## URBAN RENEWAL AGENCY AGENDA

<b>Meeting Date: August 1, 2022</b>		<b>Subject: URA Resolution No. 327</b> Authorizing the City Manager to Execute a Second Amendment to the Construction Contract with Moore Excavation Inc. for the 5 <sup>th</sup> Street / Kinsman Road Extension Project (Capital Improvement Project No. 1139, 2099, 4196, 4215, & 9155)  <b>Staff Member:</b> Zachary J. Weigel, P.E. City Engineer  <b>Department:</b> Community Development	
<b>Action Required</b>		<b>Advisory Board/Commission Recommendation</b>	
<input checked="" type="checkbox"/> Motion <input type="checkbox"/> Public Hearing Date: <input checked="" type="checkbox"/> Resolution <input type="checkbox"/> Information or Direction <input type="checkbox"/> Information Only <input type="checkbox"/> Board Direction <input checked="" type="checkbox"/> Consent Agenda		<input type="checkbox"/> Approval <input type="checkbox"/> Denial <input type="checkbox"/> None Forwarded <input checked="" type="checkbox"/> Not Applicable  <b>Comments:</b> N/A

**Exhibit A - Change Order #02  
Pay Item Adjustment**

## Exhibit B – Change Order #02 Pay Item Detailed Description

Add Standard Curb to PGE Vault 221

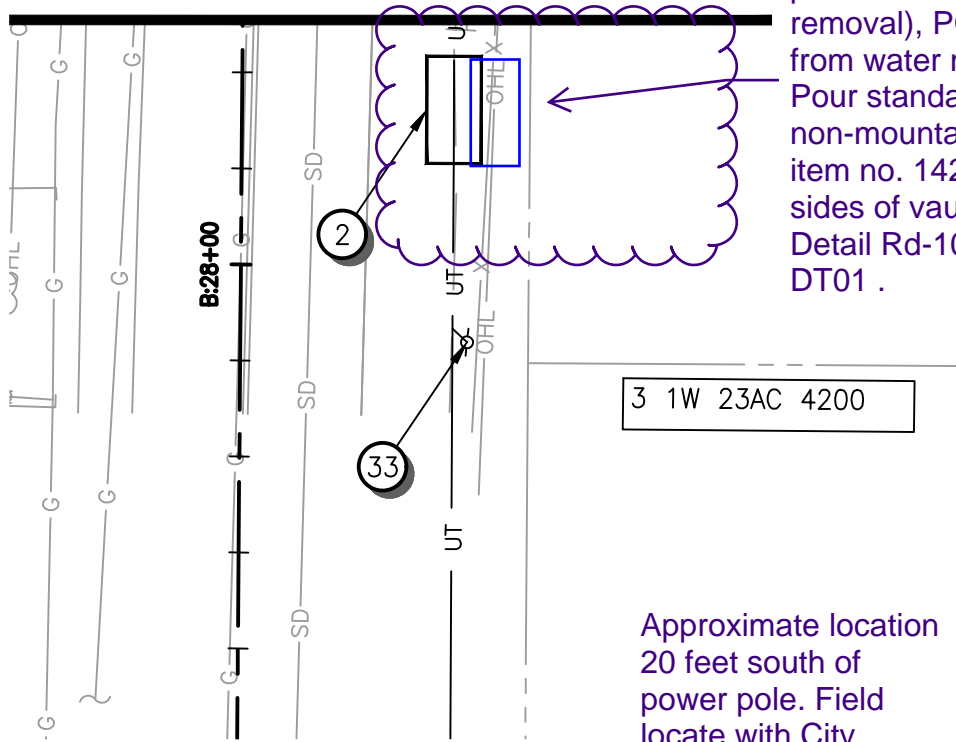
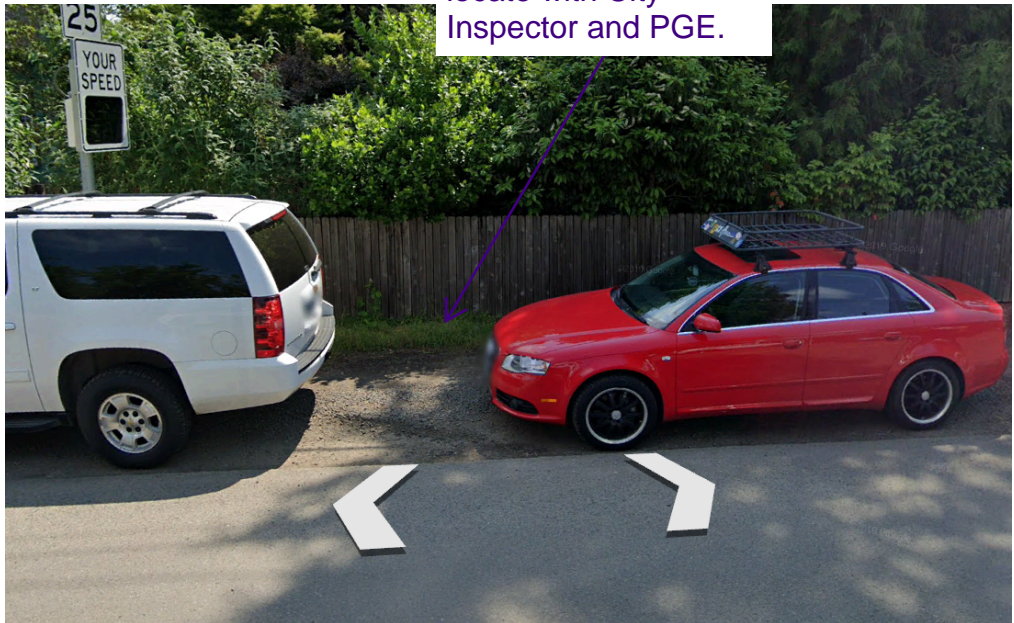
Add Standard Curb to PGE Vault 221 – During construction of the underground electrical infrastructure, PGE requested standard curb be installed along the outside edge of electrical vaults located within parking areas. PGE Vault 221 is located along an unimproved portion of Boones Ferry Road, south of 5<sup>th</sup> Street within an existing gravel area adjacent to the paved roadway. PGE vault lids are not structurally rated for traffic loading. As a result, PGE has requested standard curb be installed along the south, west, and north edges of PGE Vault 221 to prevent vehicles from driving over or parking on top of the vault lid. The design change is included on page 4 of Exhibit C. This design change results in increased estimated quantity of Pay Item 142 – Non-Mountable Median - Asphalt Streets.

Approximate location for vault 221.  
Field adjust based on fence post locations (minimal removal), PGE clearances (2' from water main)  
Pour standard 6" non-mountable median (bid item no. 142) around front and sides of vault to protect it - See Detail Rd-1065 on Sheet 122, DT01 .

Approximate location 20 feet south of power pole. Field locate with City Inspector and PGE.

SW 5TH ST TO SW KINSMAN RD EXTENSION  
 5TH ST PLAN & PROFILE - ROADWAY  
 PLAN AND PROFILE

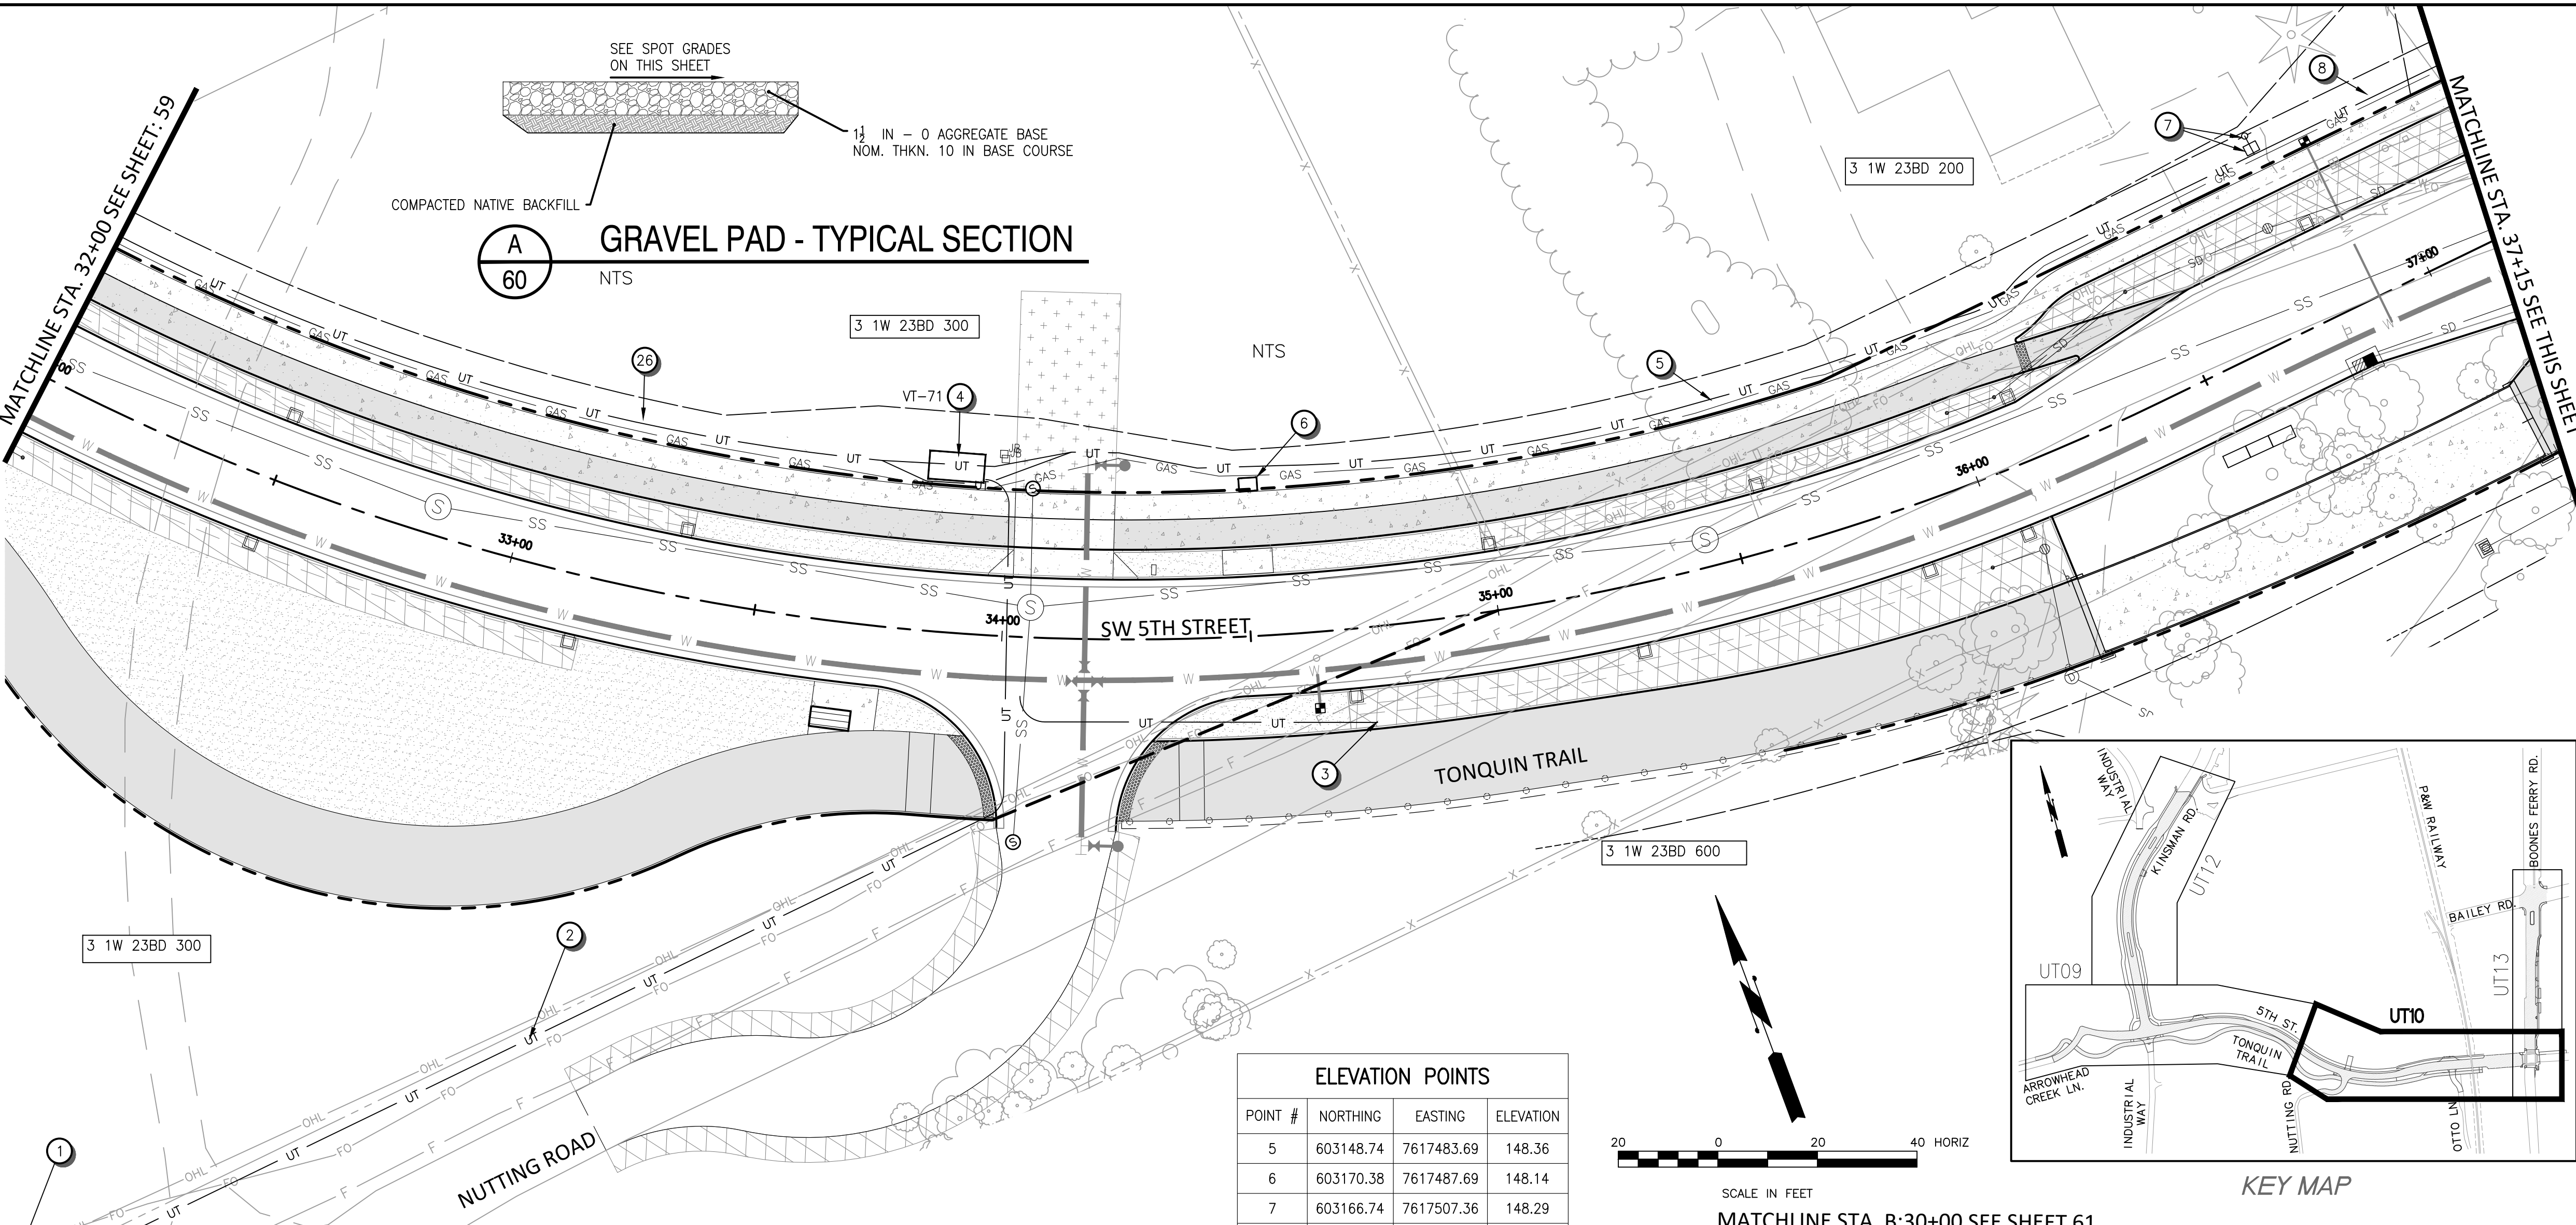
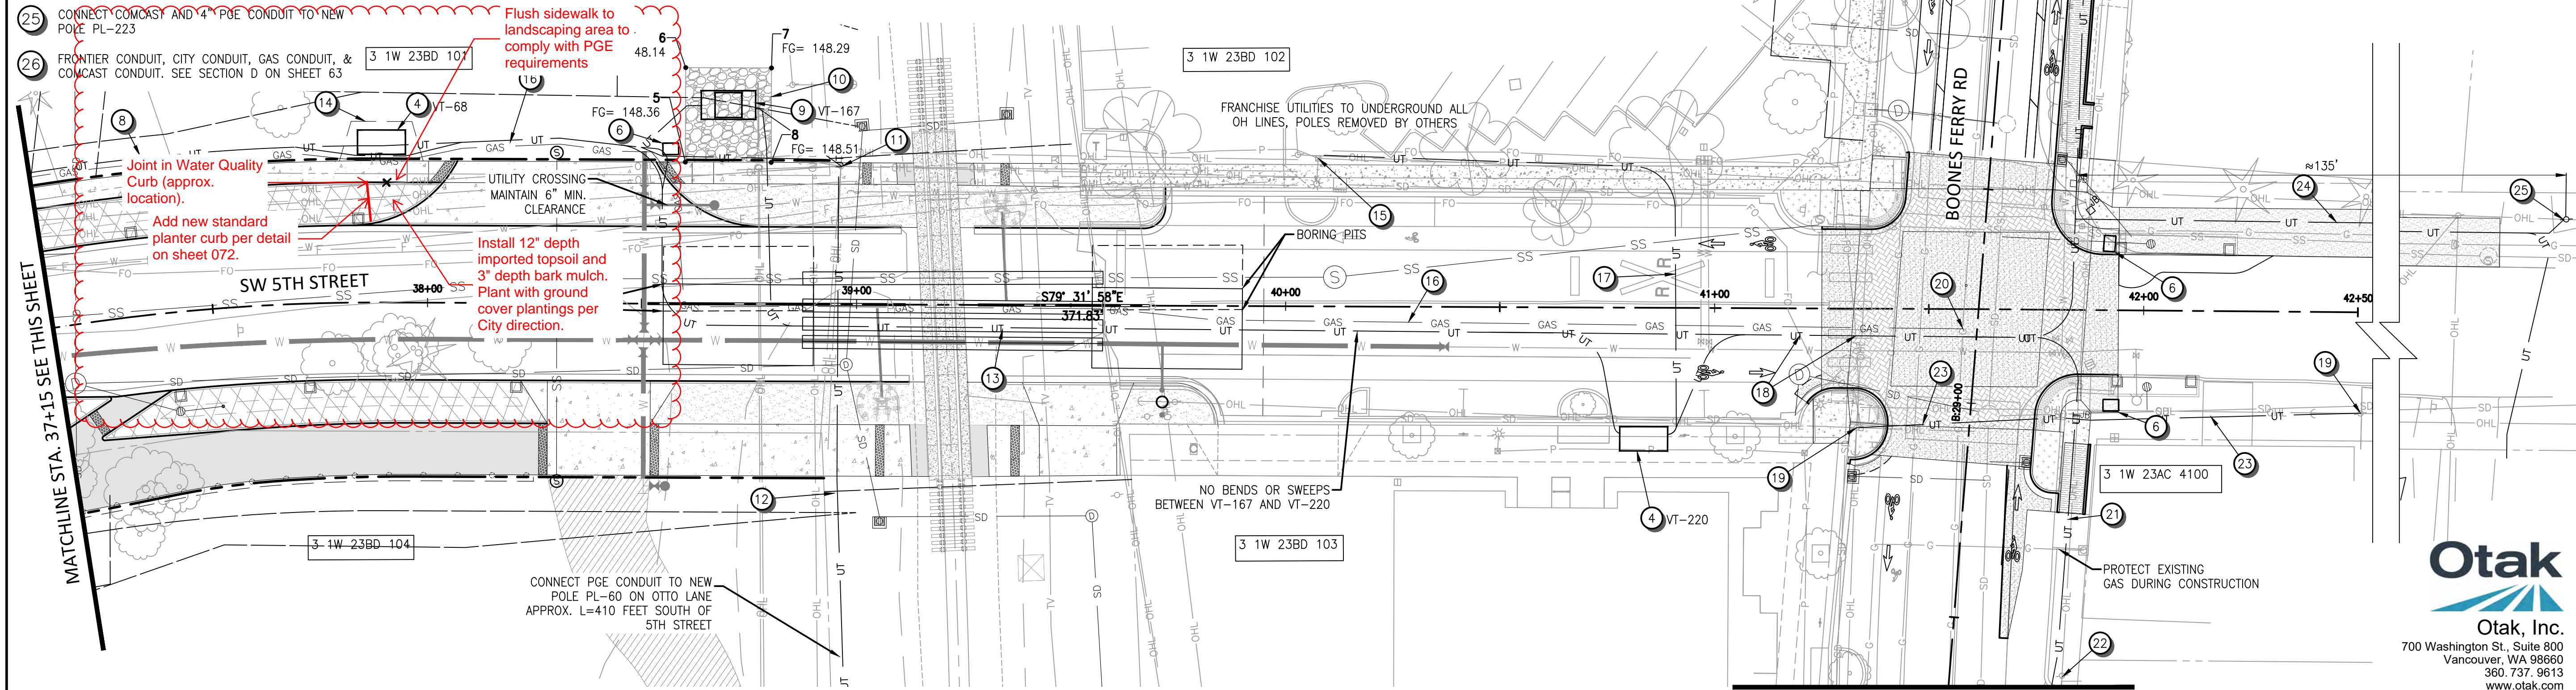
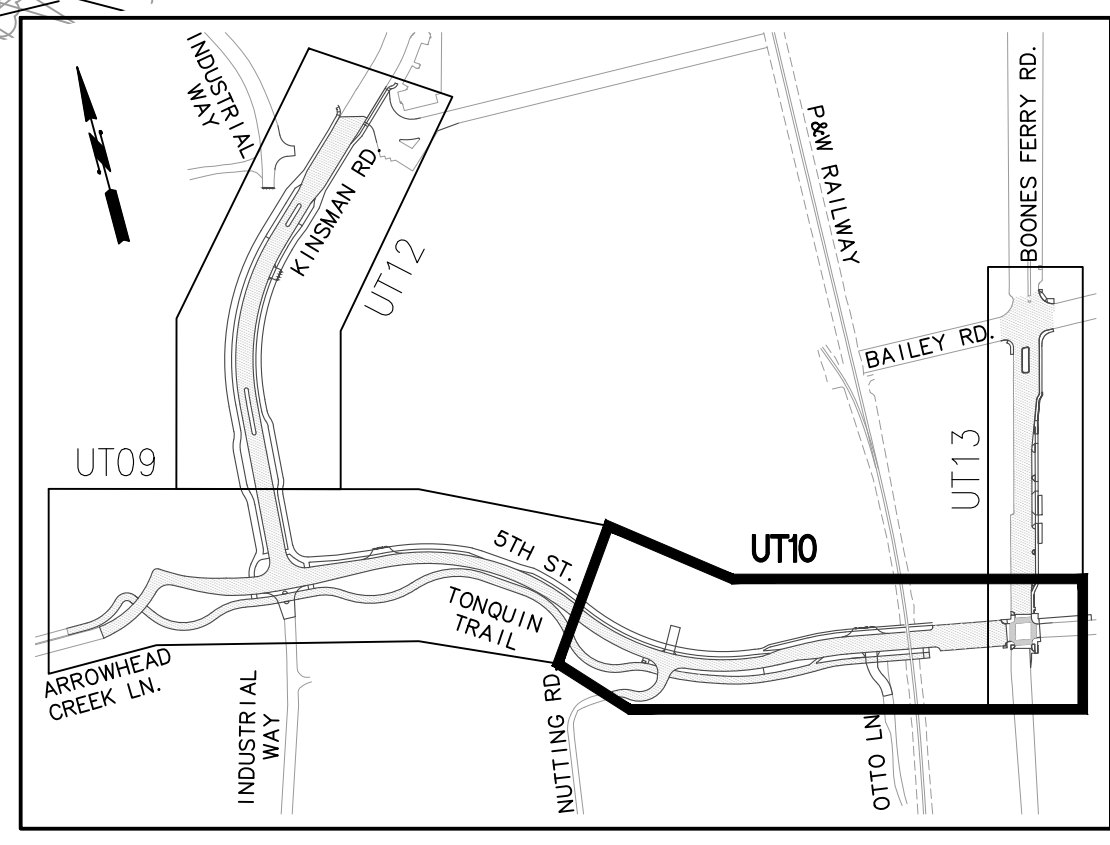
REMOVE 12-FT SECTION OF CURB IN FRONT OF 612 PGE VAULT; POUR BACK STANDARD CURB; REQUIRED PER PGE SPEC FOR ACCESS TO VAULT (SHEET UT10)

11-04-2021	REVISE PGE LAYOUT
------------	-------------------
